RE: PETITION NO. 1184 - Beacon Falls Energy Park, LLC petition for a declaratory ruling that no Certificate of Environmental Compatibility and Public Need is required for the proposed construction, operation, and maintenance of a 63.3 Megawatt AC fuel cell facility located on Lopus Road, Beacon Falls, Connecticut.

Petition 1184
Beacon Falls Energy Park (BFEP)
Development and Management Plan Interrogatories

DEVELOPMENT AND MANAGEMENT (D&M) PLAN

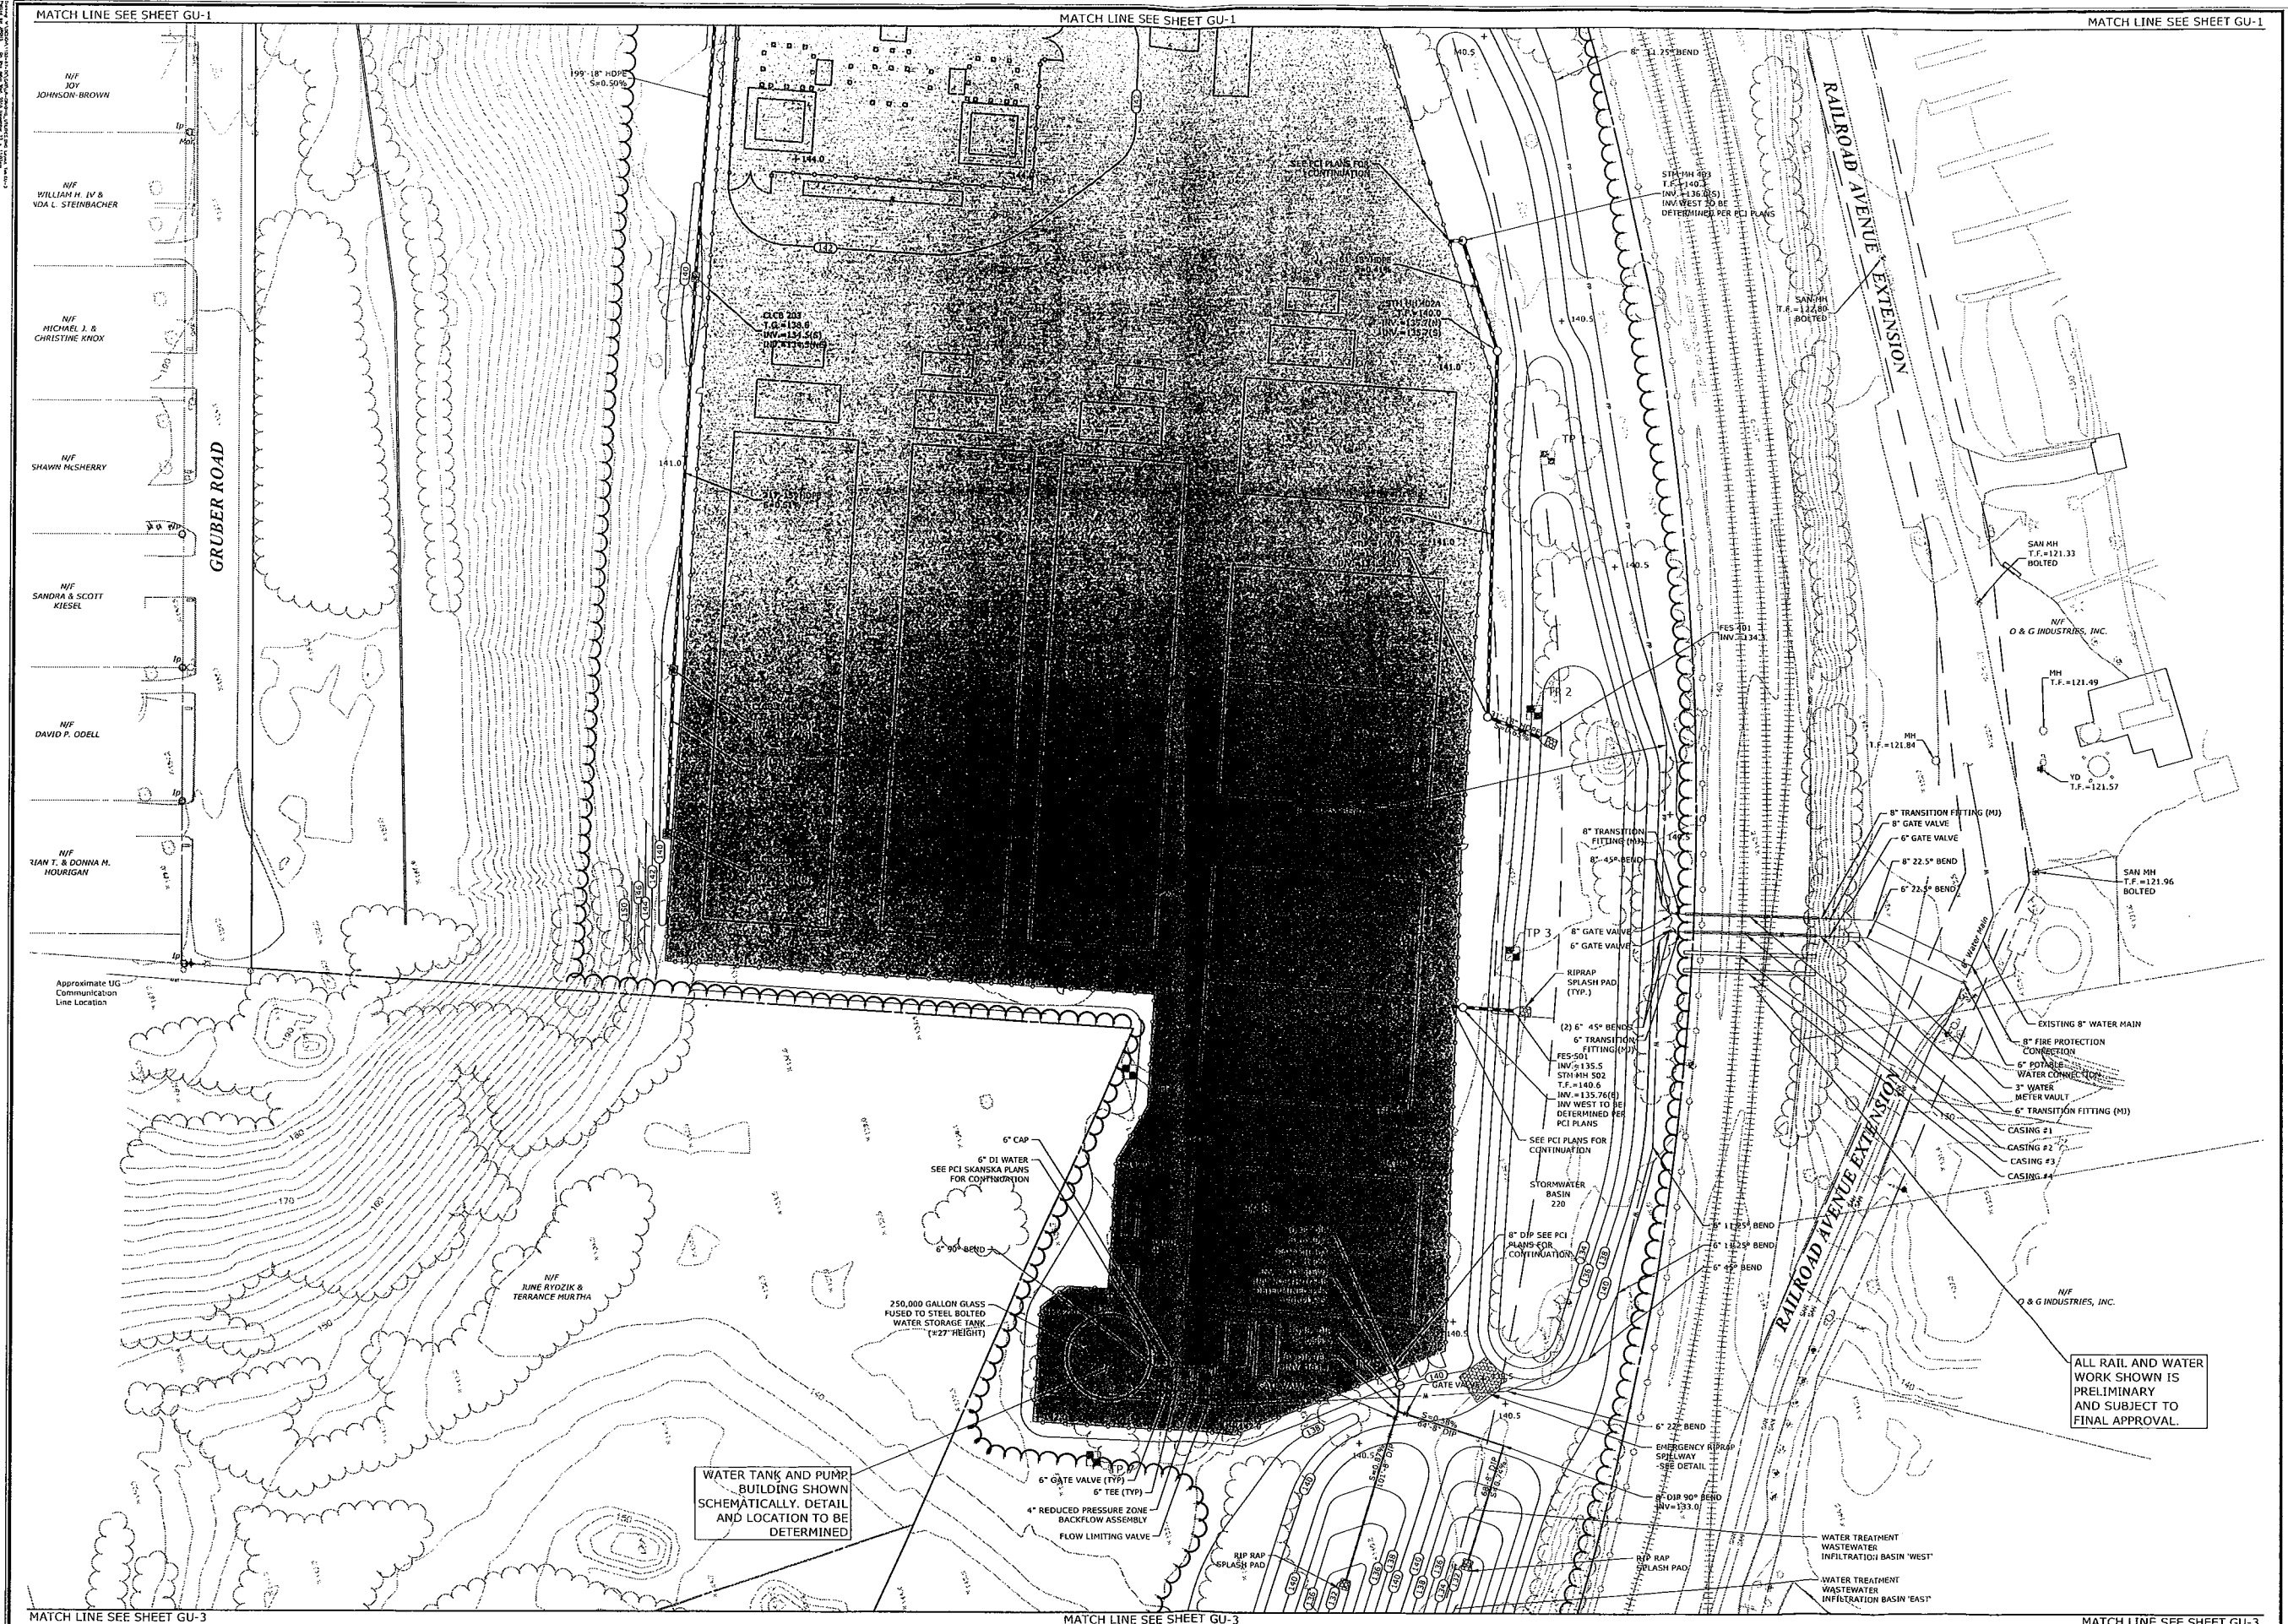
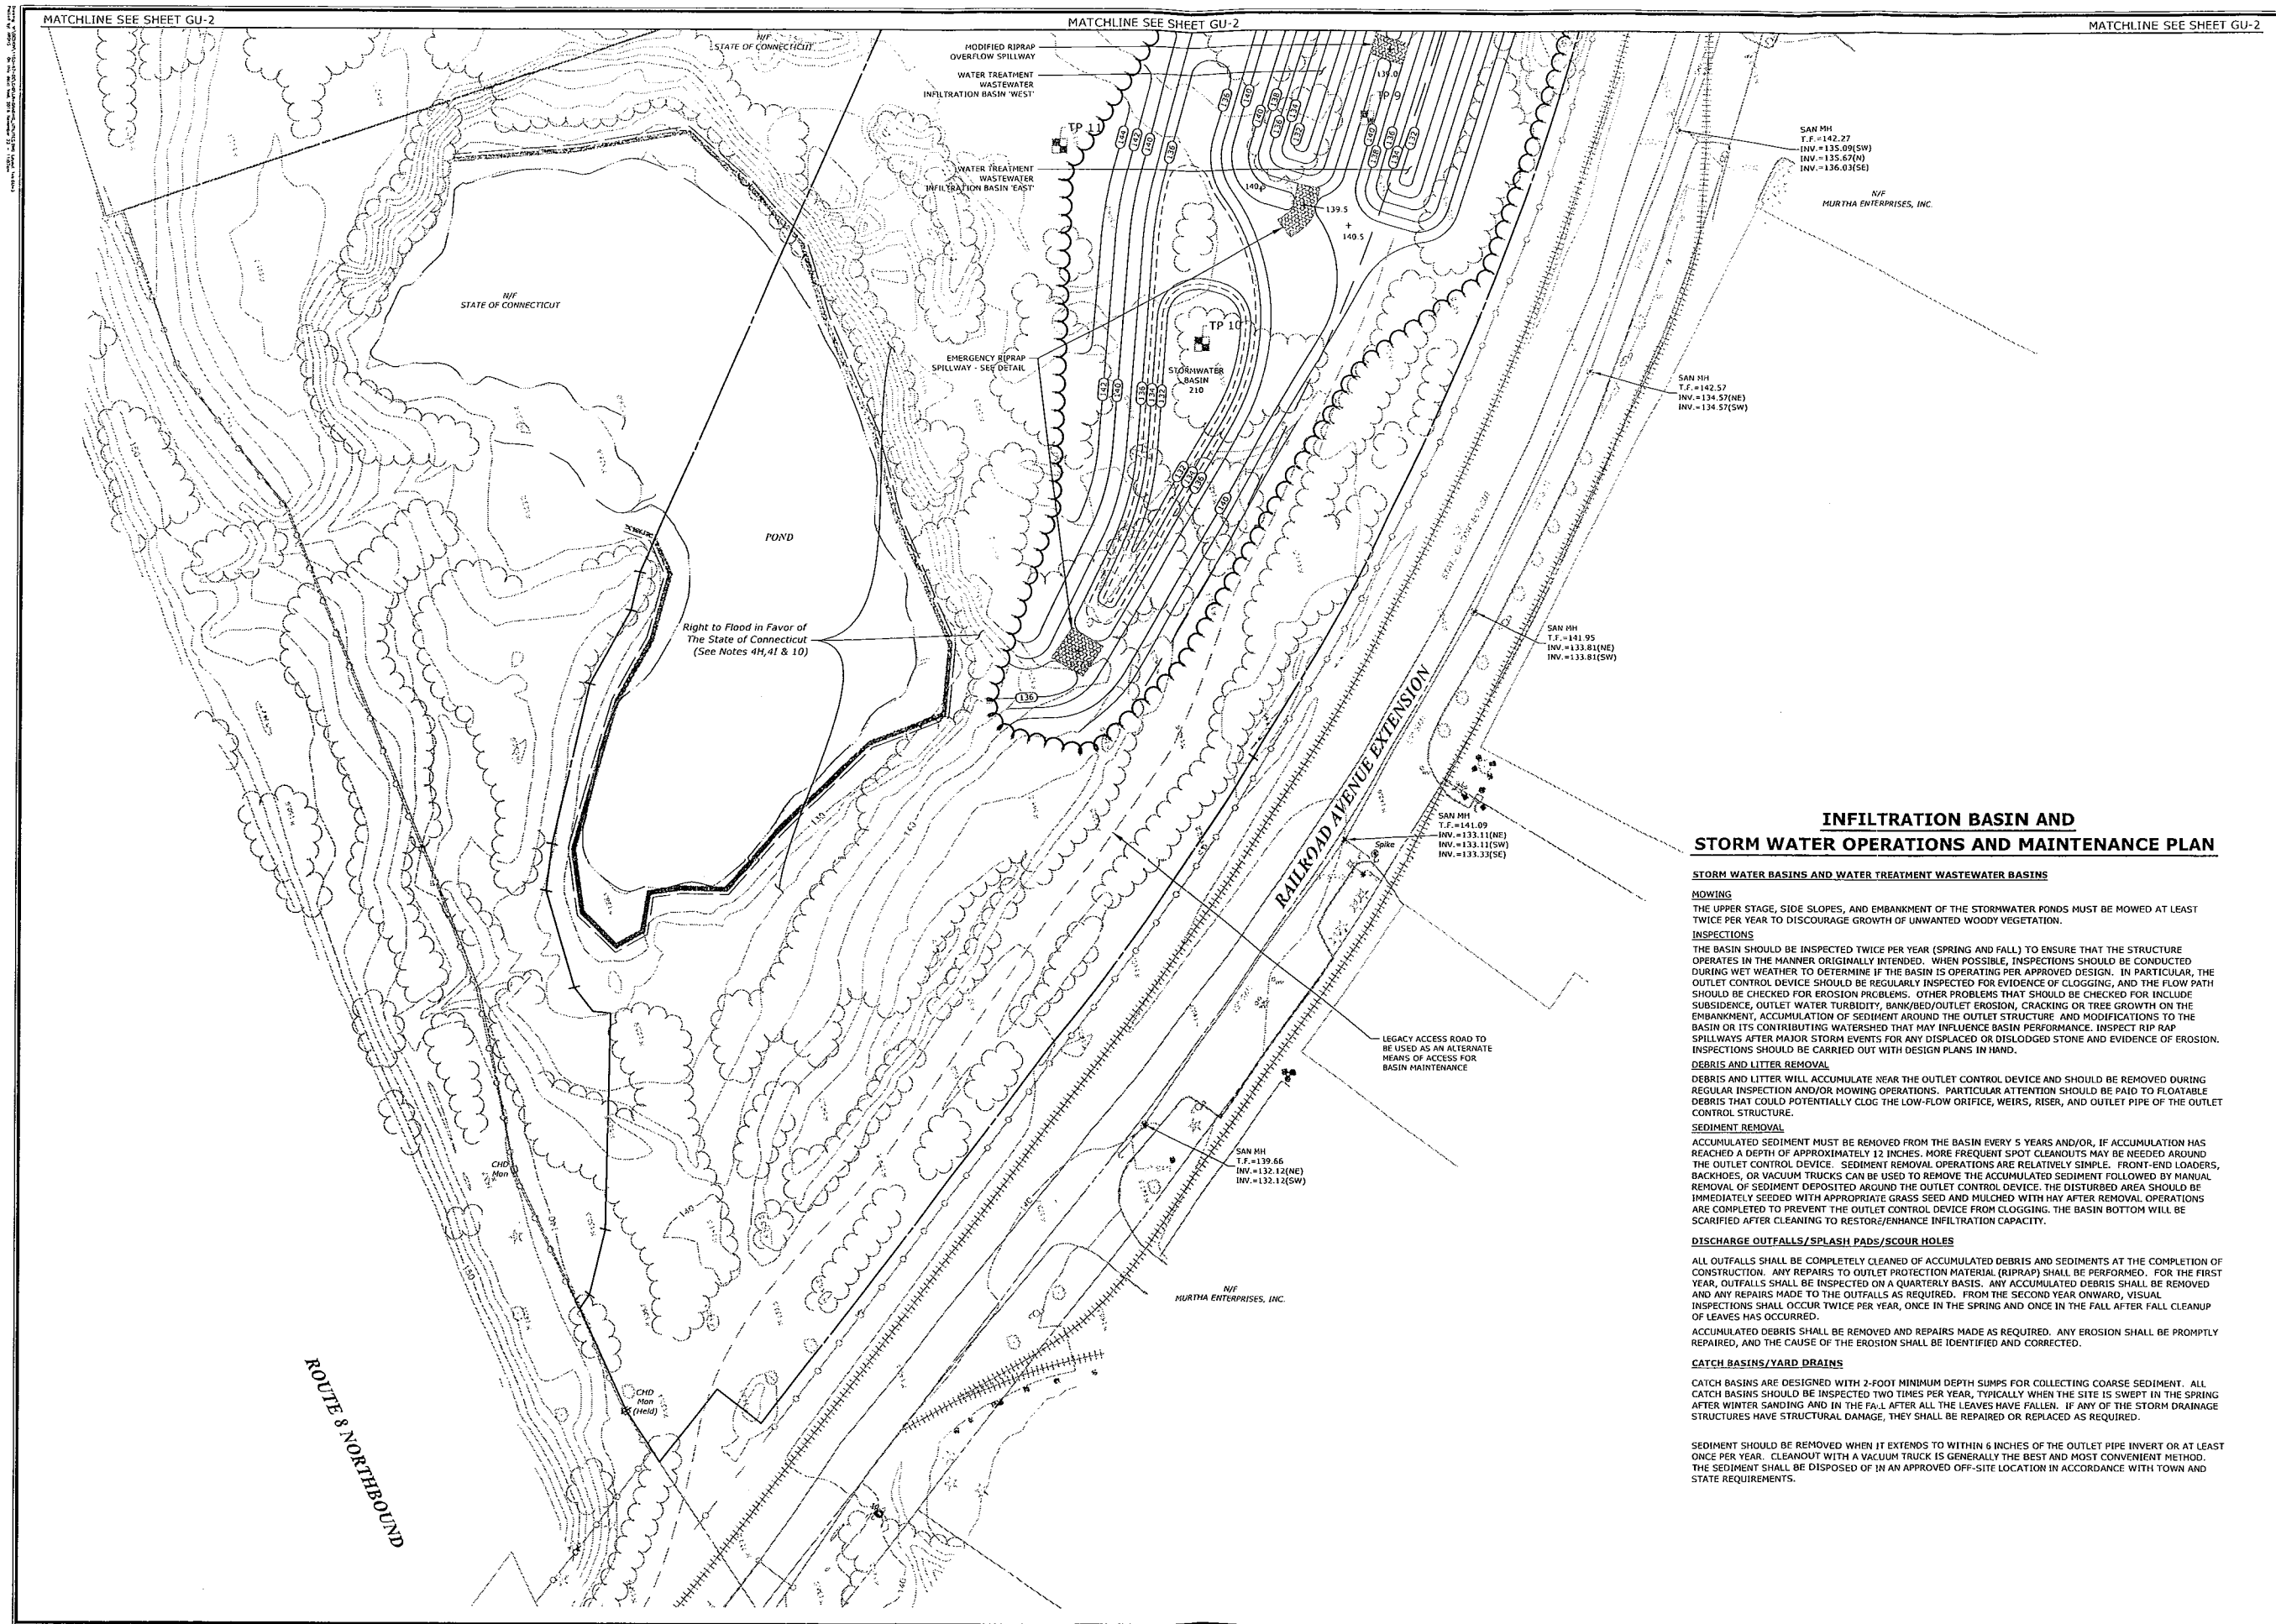
3. The General Arrangement Site Plan indicates one access point into the fuel cell compound. How will BFEP access the stormwater detention and infiltration basins for periodic maintenance if there is no defined access to the basins or an access gate on the south or west ends of the fuel cell compound?

RESPONSE: A 16 foot wide double access gate has been added to the plan, proposed for the south end of the facility to facilitate maintenance of the basins. In addition, there is a legacy access road that will be utilized as an alternate means of access for maintenance of the basins. See drawings GU-2 and GU-3.

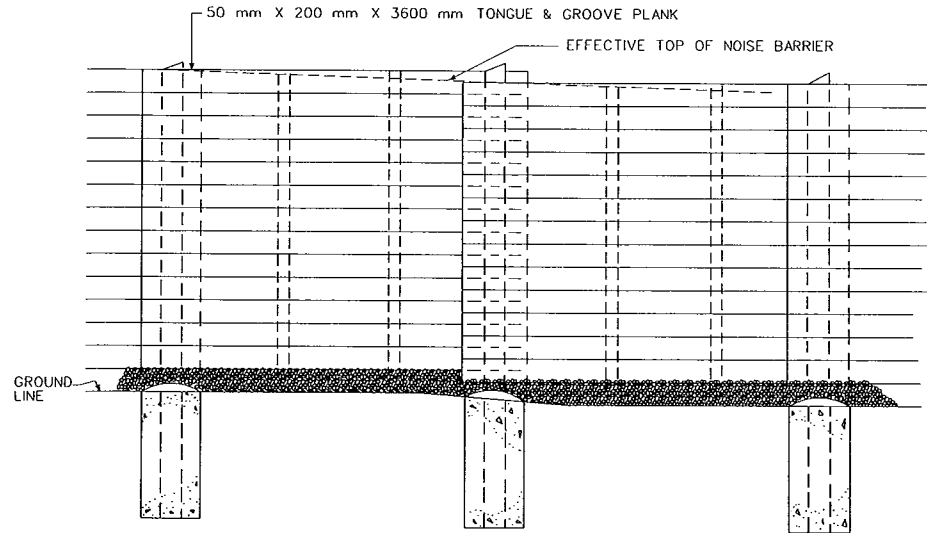
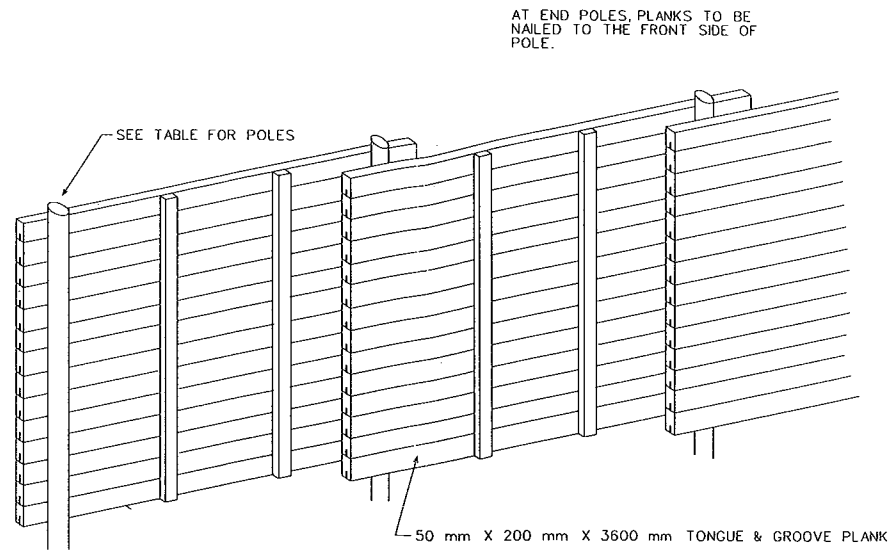
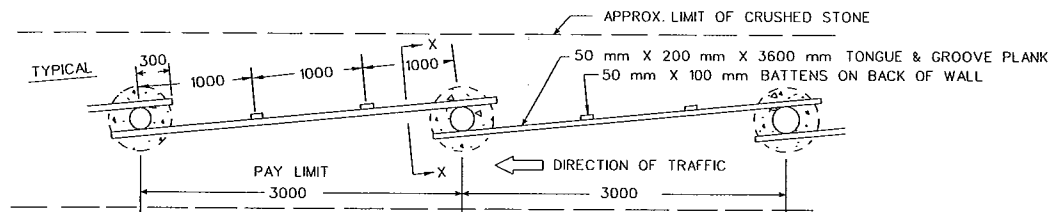
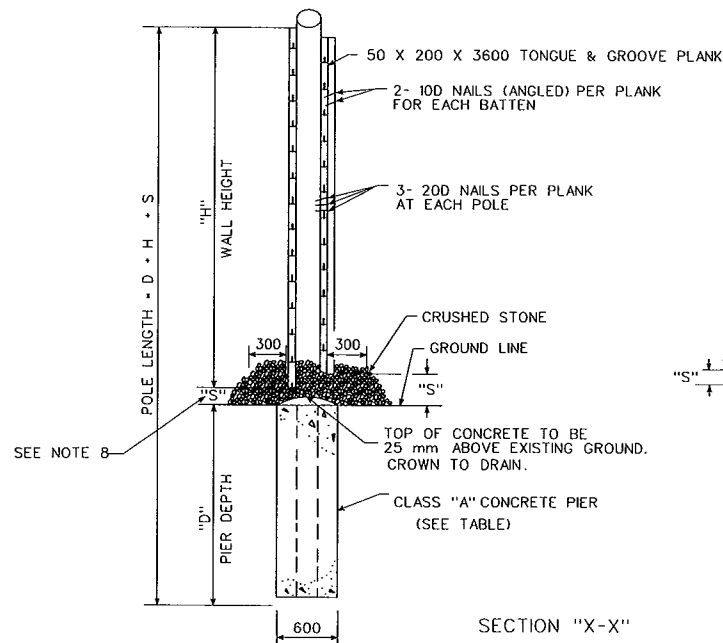
19. Page 14 of the D&M Plan narrative refers to sound wall details on Drawing MDS-21. Please submit the drawing.

RESPONSE: Drawing MDS-21 is attached.
